**BROOKHAVEN NATIONAL LABORATORY
UPTON, SUFFOLK COUNTY, NEW YORK
EPA FACILITY ID: NY7890008975
JULY 6, 2011**

**U.S. DEPARTMENT OF HEALTH AND HUMAN SERVICES
PUBLIC HEALTH SERVICE**
Agency for Toxic Substances and Disease Registry

A public health assessment (PHA) for the Department of Energy's (DOE) Brookhaven National Laboratory was released for public comment and independent peer review on September 30, 2005. Due to a lack of funding by DOE in fiscal year 2006, we were unable to respond to the comments we received. PHA Appendix H contains a copy of the stakeholder letter sent in December 2005.

Figure 3. Ten-year tritium releases from HFBR: 1994 to 2003

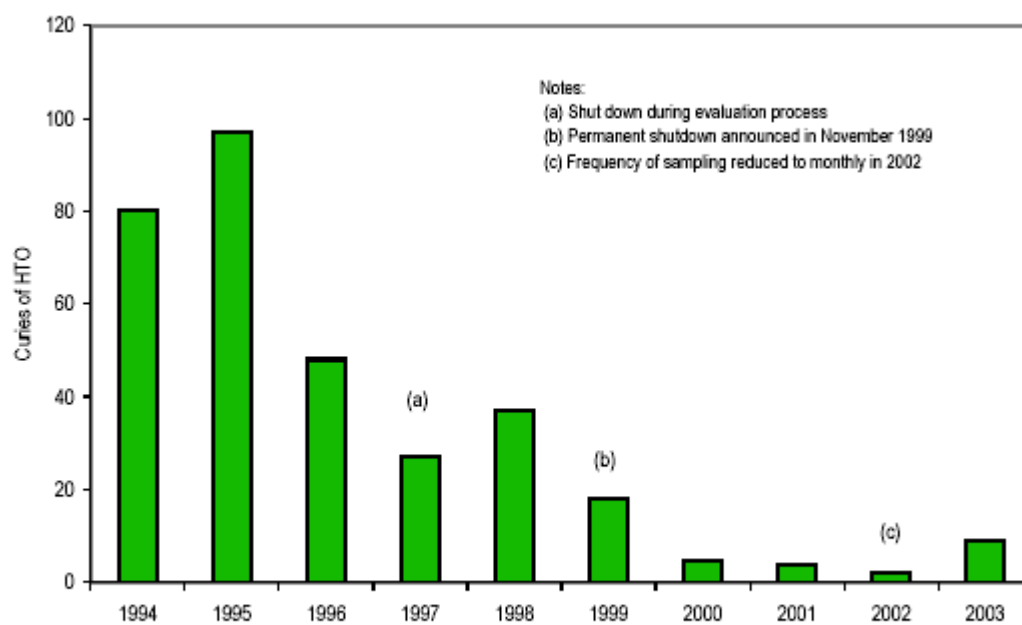
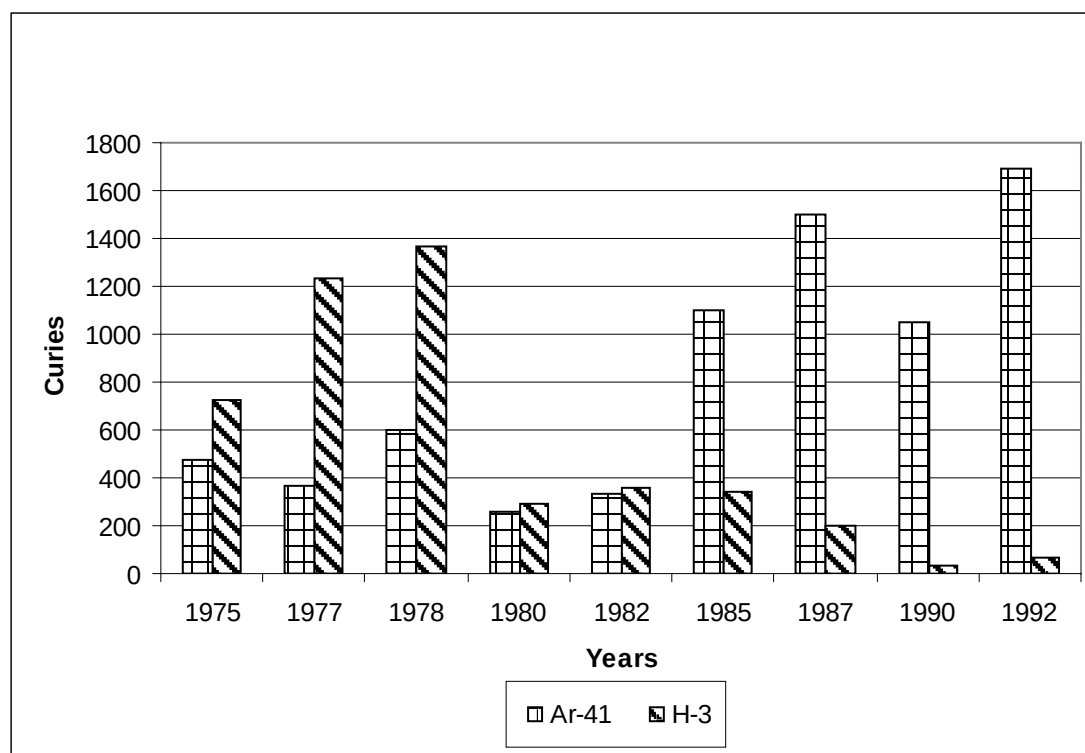
figure 3) when it has not been in operation?	November 1999. While this increase may seem unusual, readers should note that the magnitude of the increase is extremely small in comparison to past tritium emissions when this and other reactors were operational. For instance, as comparison of Figures 2 and 3 shows, the longer-term trend of tritium emissions from the HFBR quite clearly demonstrates (as one would expect) that air emissions in every year since shutdown were considerably lower than air emissions during years of active operations. Moreover, as comparison of Figures 1 and 3 shows, the historical emissions of tritium from the Van De Graaff Accelerator (VDGG) operations far outweigh the recent increase in tritium emissions observed in 2002. Nonetheless, to be responsive to this comment, ATSDR has added text to the section in question offering some explanations for why the tritium emissions recently increased (e.g., due to evaporative losses during groundwater remediation activities), and ATSDR has revised the titles of Figures 1, 2, and 3 to emphasize the different time frames that the individual figures cover.
